2007/2008 PROPOSED CHANGES TO THE INTERNATIONAL PLUMBING/PRIVATE SEWAGE DISPOSAL CODE

PLUMBING/PRIVATE SEWAGE DISPOSAL CODE COMMITTEE

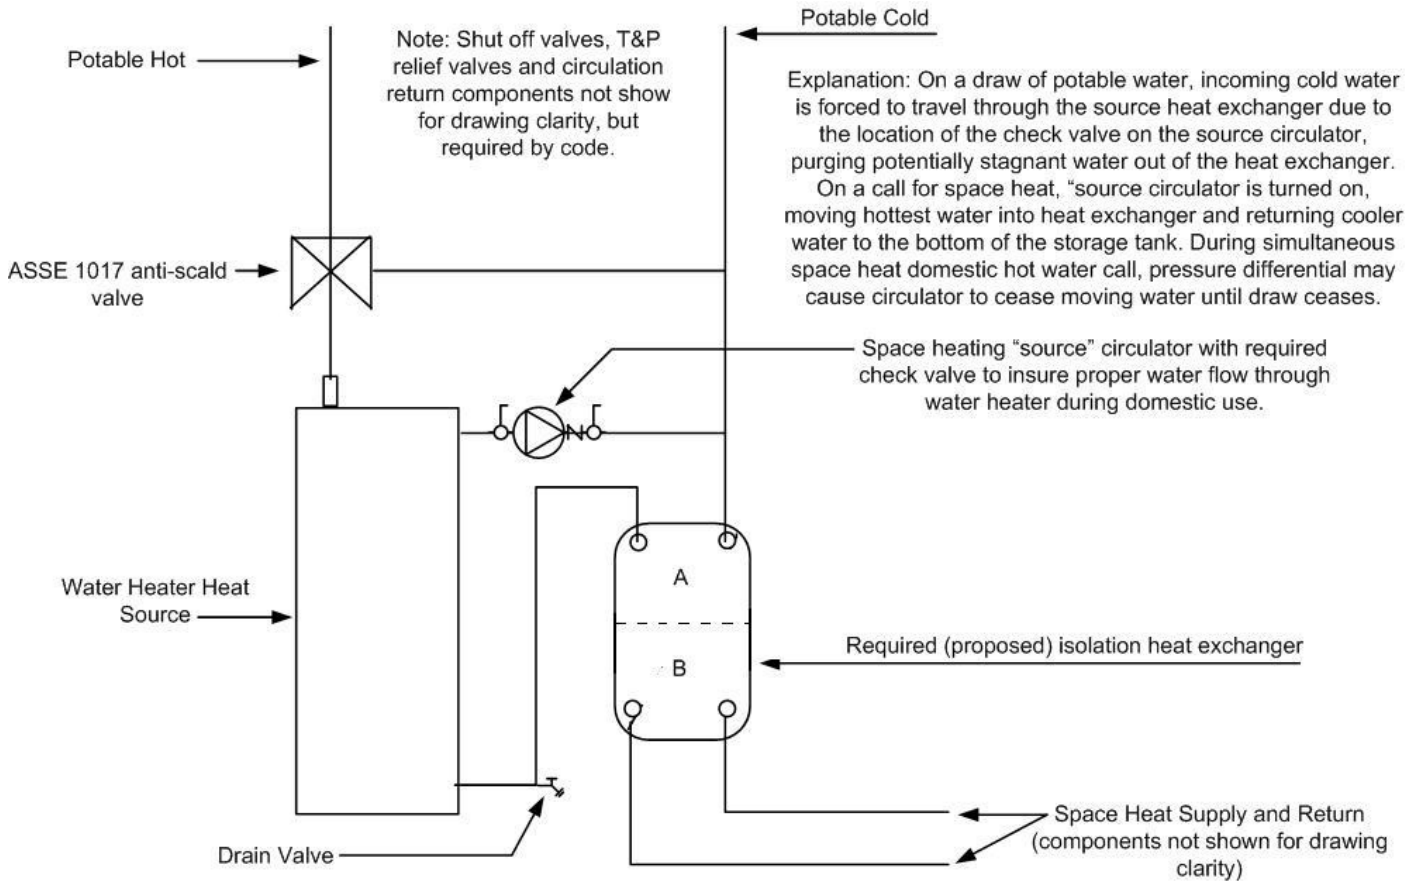
This stagnant, warm water is prime breeding ground for Legionella bacteria, the cause of Legionnaires’ disease. Legionella bacteria are commonly found, in small numbers, in all potable water systems – both municipal and private well systems. Many studies have found that Legionella bacteria multiply when the following four conditions are met:

1. water pH of 5.0 to 8.5,
2. temperatures between 55F and 133F (with the ideal range being 80F to 122F),
3. stagnant conditions and
4. the presence of bio-films/rust/sediment (a food/shelter source).

The stagnant, warm water in the space-heating loop satisfies all the requirements for reproduction of Legionella bacteria.

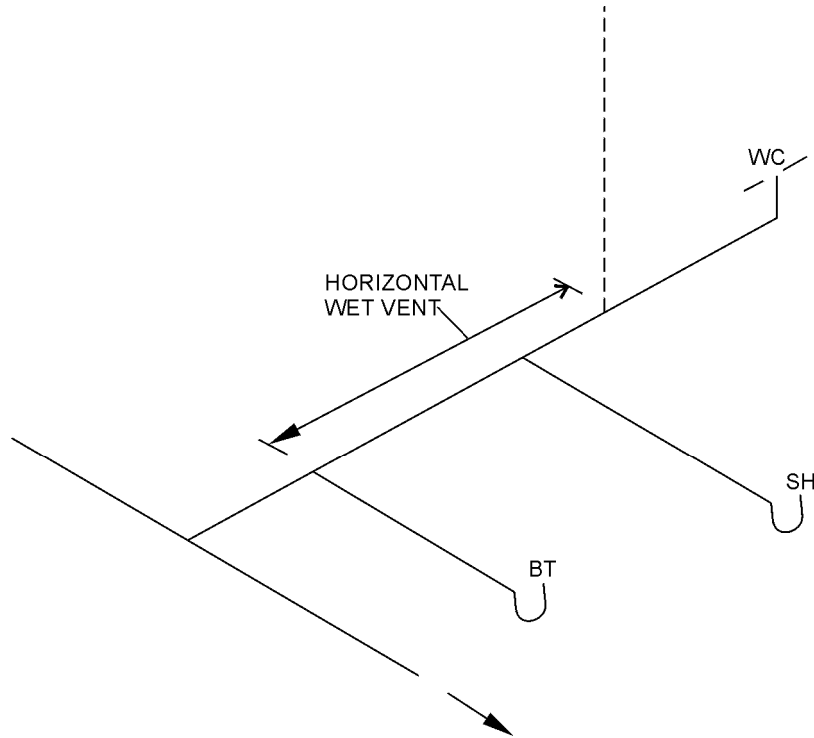
P3108.2 Dry vent connection. The required dry-vent connection for wet-vented systems shall comply with Sections P3108.2.1 and P3108.2.2

P3108.2.1 Horizontal wet vent. The dry-vent connection for a horizontal wet-vent system shall be an individual vent or a common vent for any bathroom group fixture, except an emergency floor drain. Where the dry vent connects to a water closet fixture drain, the drain shall connect horizontally to the horizontal wet vent system. Not more than one wet-vented fixture drain shall discharge upstream of the dry-vented fixture drain connection.

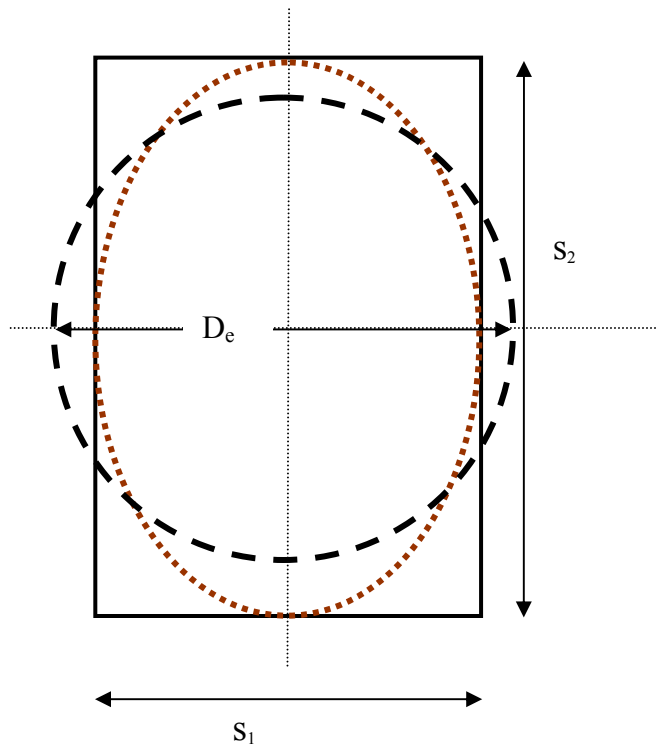
Table 1106.2 of the 2006 International Plumbing Code is based on empirical investigations of circular leaders. The table provides, for the purposes of design, the relationship between roof area, rainfall rates and the required leader diameter. The Metal Building Manufacturers Association has performed an engineering study to determine a more reasonable rationale for determining the flow capacity of rectangular vertical leaders. This proposal uses simple geometry to conservatively equate the allowable horizontally projected roof area when utilizing rectangular leaders to the allowable areas in Table 1106.2. Applied in the practical range of rectangular leader cross-section geometry, this method would

continue to be somewhat conservative without unduly penalizing the capacity of rectangular leaders. One way of looking at this in terms of equivalent flow capacity is to imagine forming a circular leader into an ellipse while maintaining its circumference and inscribing this ellipse such that it intersects the midpoint of all four sides of the rectangular leader.

The following is the algebraic derivation of the equivalent circular diameter, D_e . The rectangular leader, inscribed ellipse, and the "equivalent" circular diameter are shown in the attached figure. The values in proposed Table 1106.2.2 are based on: (1) Determining the area of an inscribed elliptical area based on the S_1 (Length) and S_2 (Width) dimensions of the rectangular leader, (2) using the area of this inscribed ellipse to determine the diameter of an equivalent circle (D_e) and assigning either the published value or an interpolated value from renumbered Table 1106.2.1 for the equivalent diameter circle to the rectangular leader to determine the maximum horizontal projected roof area that can be drained using the rectangular leader for each rainfall rate.
